Attachment I  
Marked-up Technical Specification Pages

Attachment II  
Justification and Safety Analysis

ATTACHMENT III  
Analysis to Support the Conclusion of No Significant Hazard

FIGURE 2.1-1  
REACTOR CORE SAFETY LIMITS - FOUR LOOPS IN OPERATION

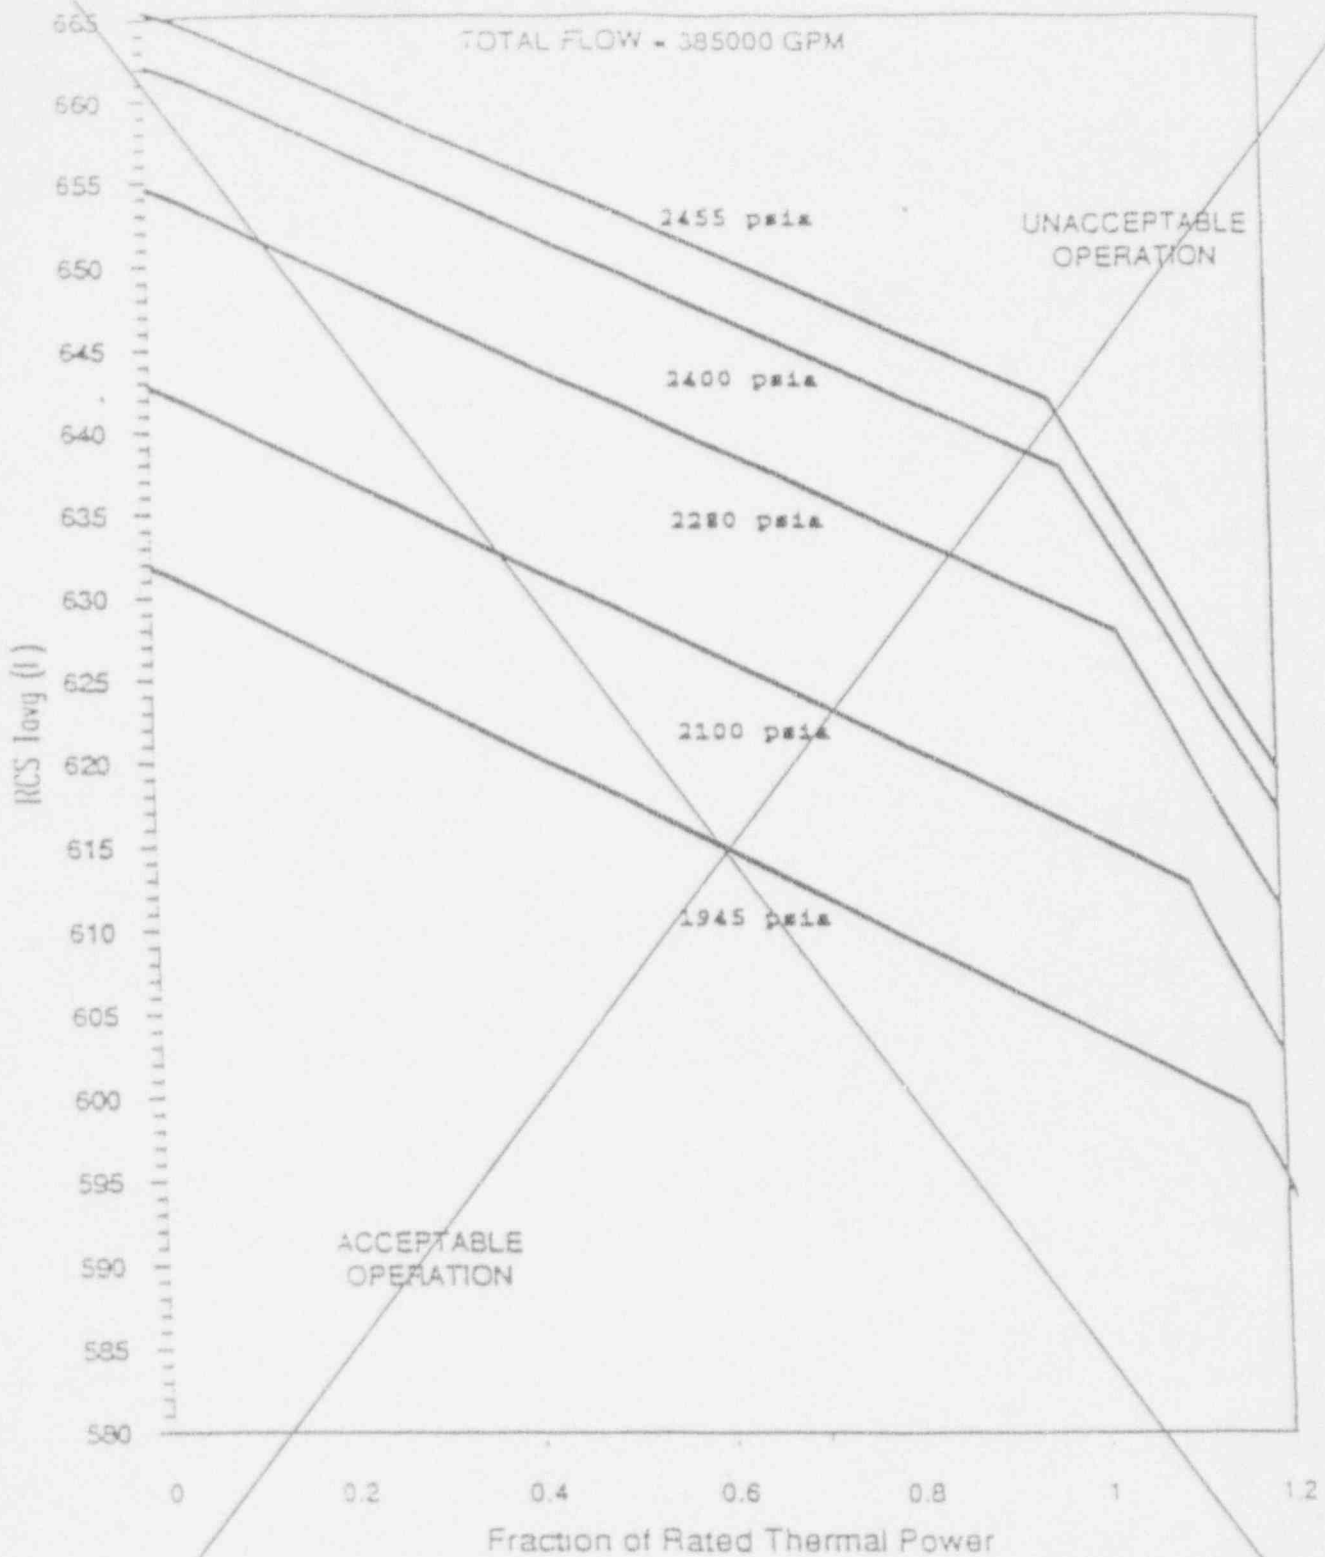
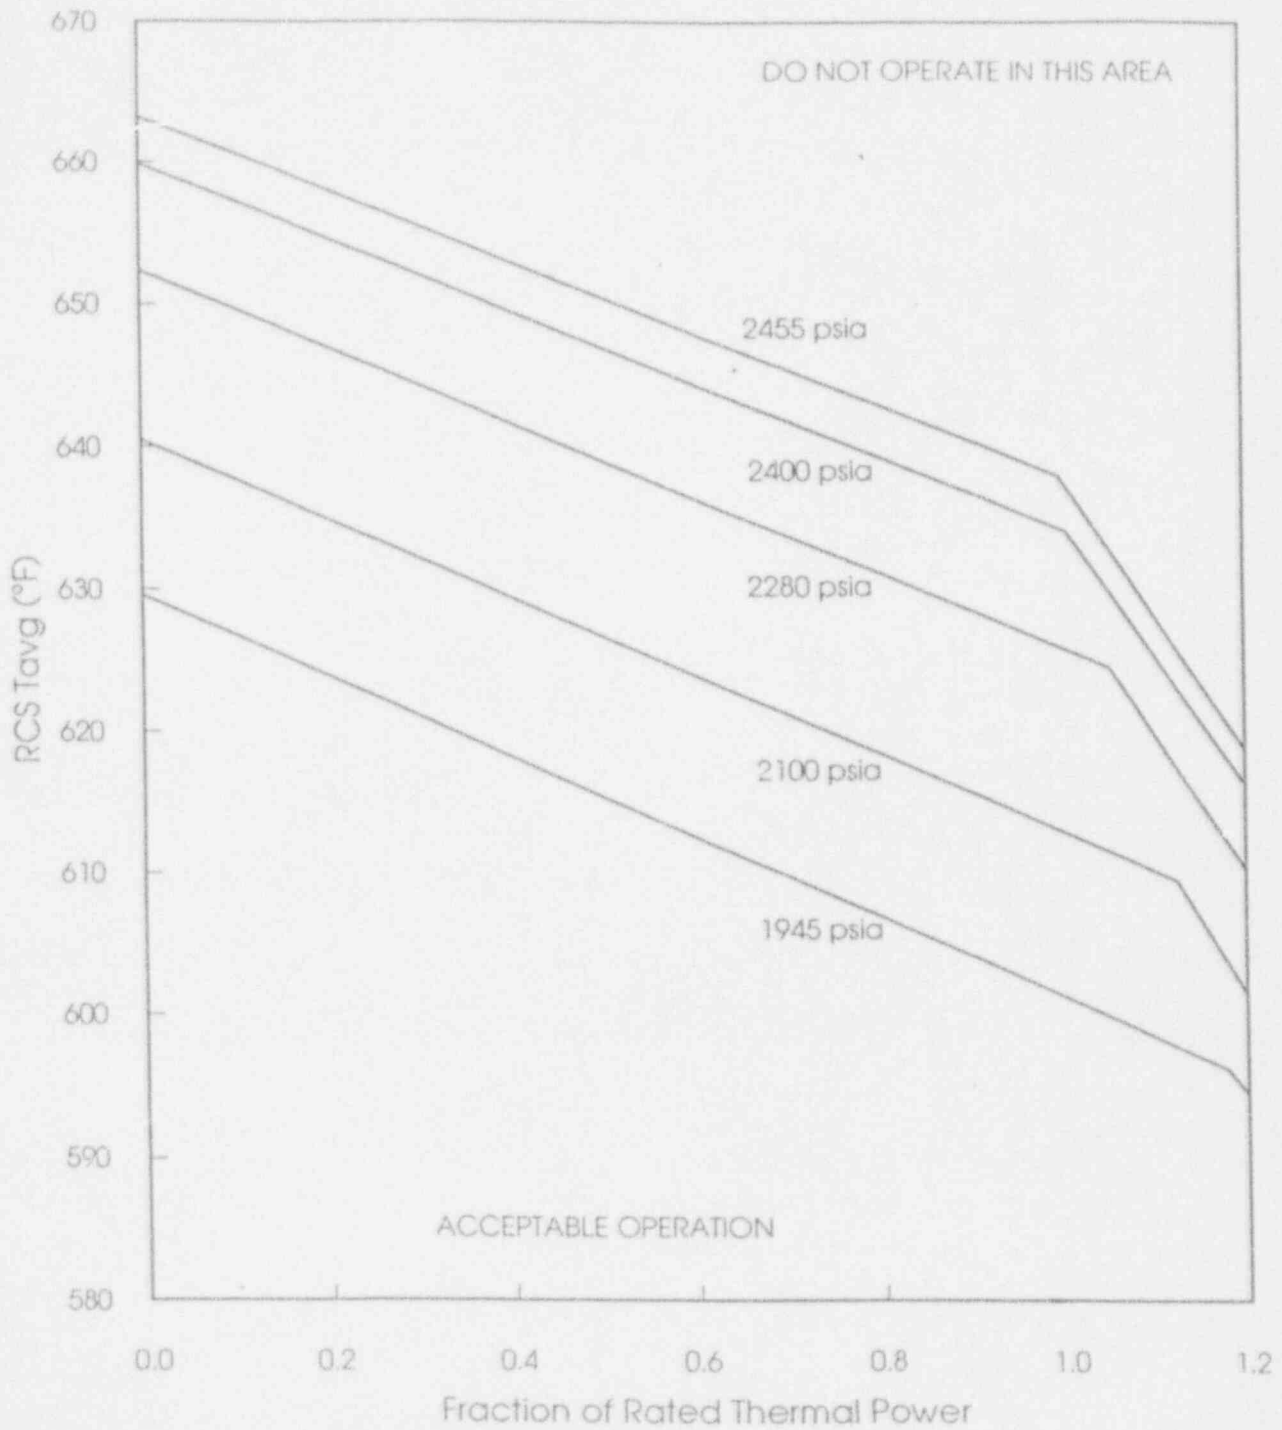
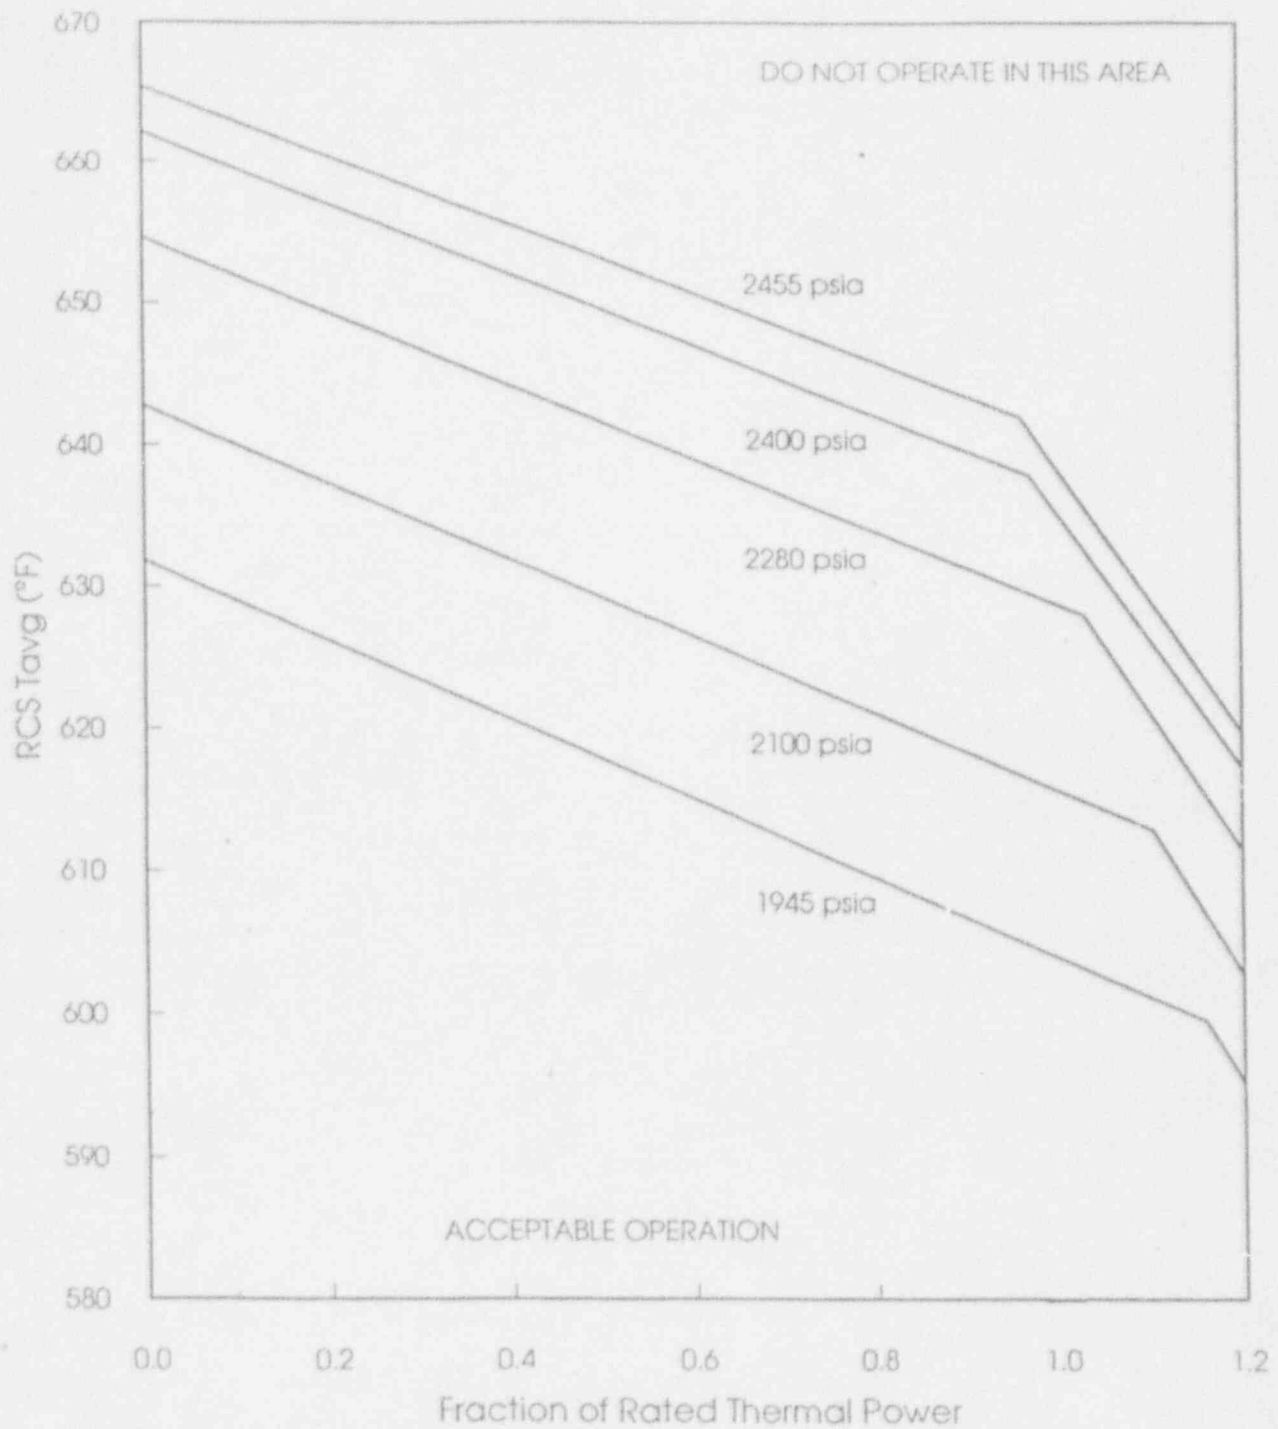
REPLACE

Figure 2.1-1a  
REACTOR CORE SAFETY LIMITS - FOUR LOOPS IN OPERATION  
382,000 gpm

Figure 2.1-1b  
REACTOR CORE SAFETY LIMITS - FOUR LOOPS IN OPERATION  
385,000 gpm

The thermal hydraulic design for Catawba Unit 1 was analyzed with the reduction in RCS minimum measured flow (MMF) to 382,000 gpm. The reduced flow rate resulted in a slight reduction of the margin in the core DNB limits. Technical Specification Figure 3.2-1, Reactor Coolant System Total Flow Rate Versus Rated Thermal Power - Four Loops In Operation, was revised to reflect the lower allowable flow rate. The Axial Flux Difference limits, Technical Specification Section 3.2.1, are unchanged and all of the current thermal hydraulic design criteria are satisfied at the reduced flow conditions.
